## Department of Planning and Development

**FILE NUMBER:** PLN23-010  
**SUBJECT:** Building Site Approval, Design Review, and Grading Approval for a Single-Family House and a Prefabricated Barn.  
**SITE LOCATION:** 10818 Crothers Rd, San Jose, CA 95127 (APN: 612-44-033)  
**DATE RECEIVED:** June 05, 2023

**Guidelines for Grading and Hillside Development**

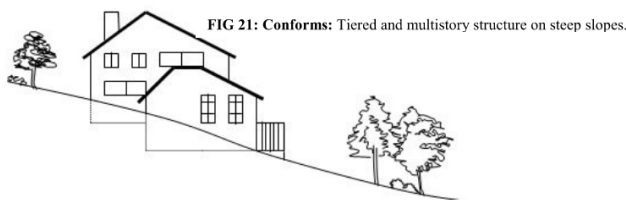
- Grading Findings require substantial conformance with applicable provisions of the [Guidelines for Grading and Hillside Development](#), adopted by the Board of Supervisors. As currently proposed (grading plans C7&8; elevations A3&4), Staff has concerns with the site design and may not make the Grading Findings. Staff recommends including steps in the building foundations and varied roof heights and plans and incorporating a tiered design approach to reduce visual bulk.

*Guideline 11: New buildings located on steeper slopes that are visually prominent should incorporate a **tiered design approach** in order to reduce building massing and visual bulk. Design methods include **steps in the building foundations and varied roof heights and planes.** (Refer Policies R-GD—27, R-GD-32)*
